Three Mile Island Nuclear Station, Unit II (TMI-2)
Operating License No. DPR-73
Docket No. 50-320
Submerged Demineralizer System Technical Evaluation Report

Your letter NRC/TMI-80-89, dated May 16, 1980, requested additional information to enable your evaluation of the subject report.

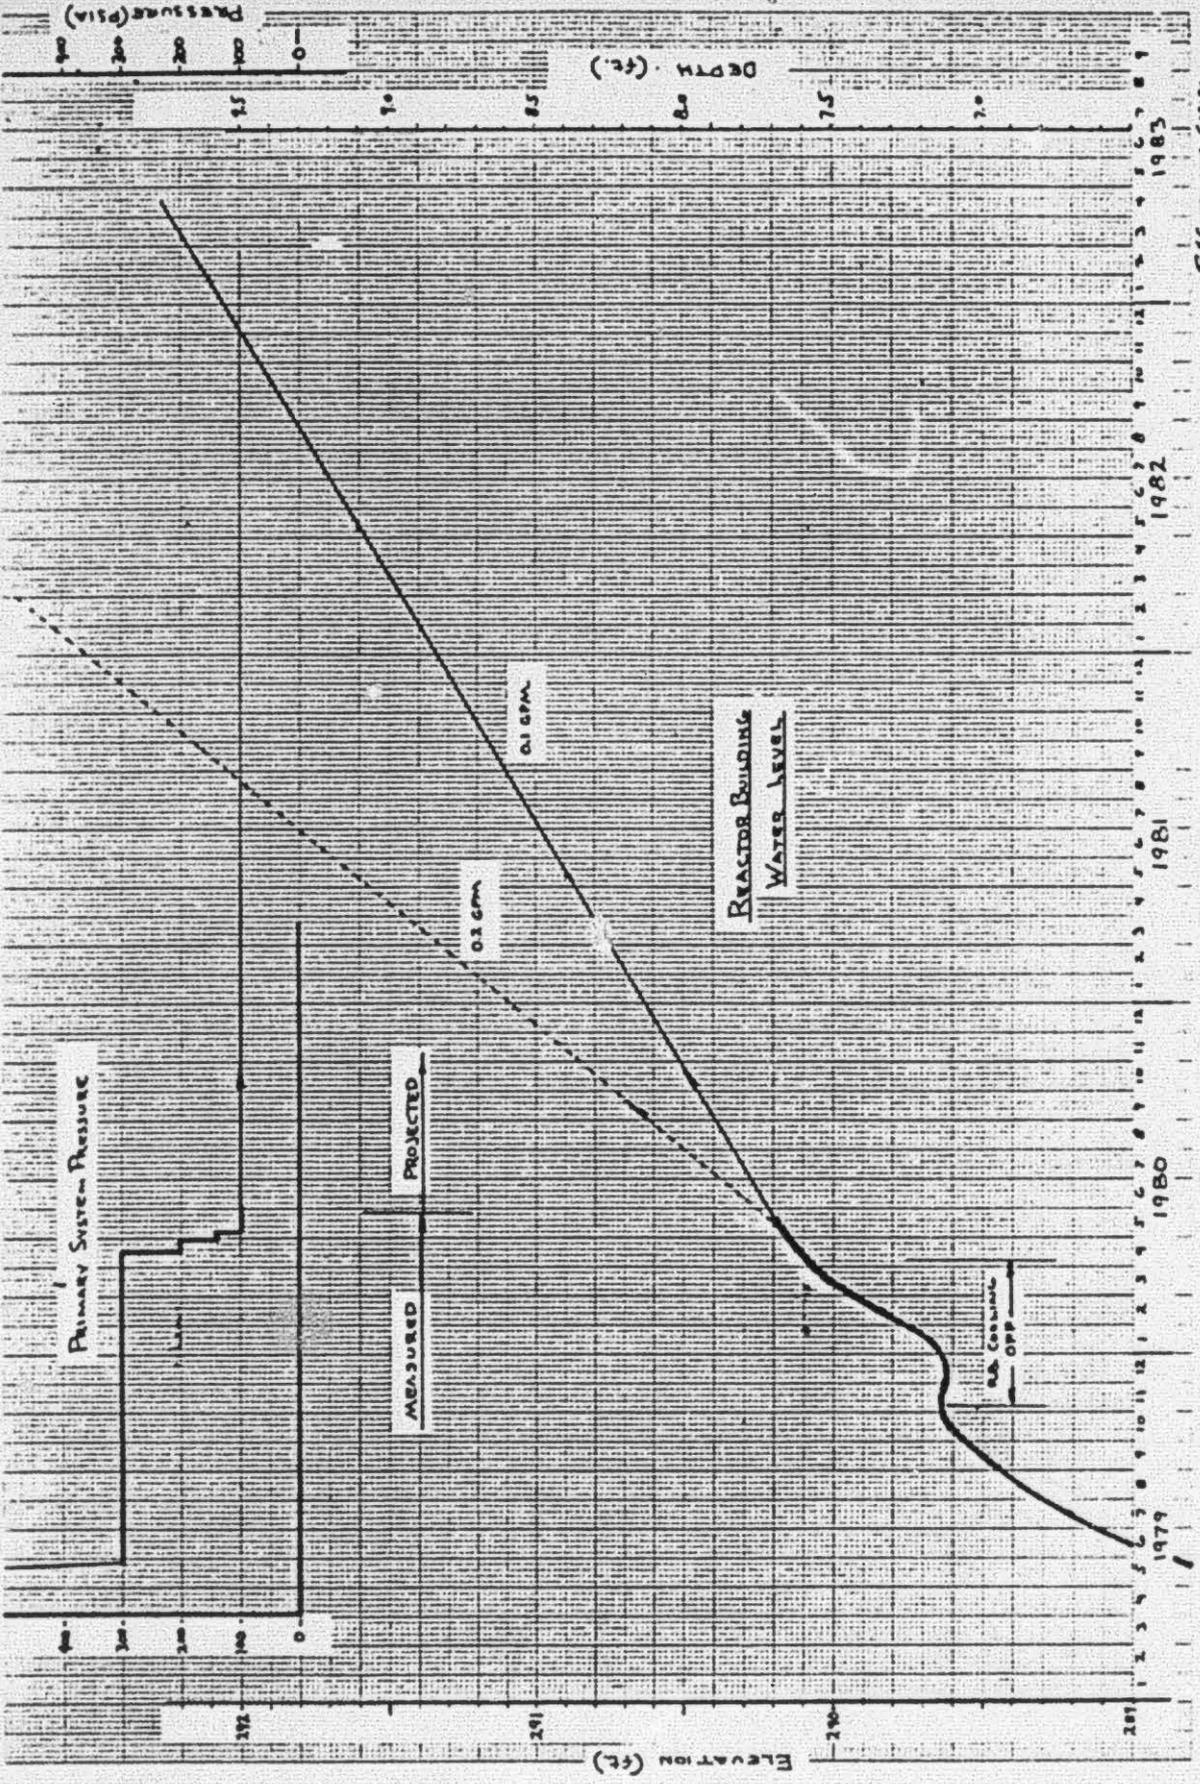
Based on past experience, project the Reactor Building water level for the next two years and list the critical instruments that may be affected by the water level you projected.

2.1 The projected water level in the Reactor Building for July 1, 1982 is 291.7 feet or a depth of 9.2 feet from the RB floor. This projection is based on the current water depth of 7.7 feet (as of May 15, 1980) with an inflow leakage of ~ 0.1 gpm from the Reactor Coolant System (RCS). This inflow leakage rate has been detected during the period of time that the RCS has been maintained at a pressure of ~ 100 psi (DVM).

As a bounding (worst case) estimate - a higher leak rate was also studied. An inflow leakage of 0.2 gpm was indicated from sump level measurements during the time that the RCS was maintained at ~ 300 psi. Thus, an upper elevation of the water depth could be 10.7 feet by July 1982 should the RCS pressure be returned to 300 psi. The projected depth at the postulated leakage rate of 0.2 gpm would be 293.2 feet.

A plot of the measured Reactor Building water level indicates that a fluctuation can be expected from deactivation of the Reactor Building Cooling Water. This type of action allows the R.B. humidity level to approach 100%. As condensation occurs on all components that are cooler than air, the sump water is transferred to higher elevation collection areas. When these collection areas become saturated or filled, the accumulation rate in the sump resumes at a rate matching the inflow leakage rate. When the RB cooling water is activated the collected water evaporates due to the lower humidity and is returned to the sump by condensing at the cooling coils which are drained into the sump. The type of water accumulation fluctuation shown by this figure is expected to occur seasonally, thus, the projected straight line increase of 0.1 gpm will fluctuate depending on RB Cooling System operation, but the average leakage from the RCS will be 0.1 gpm.
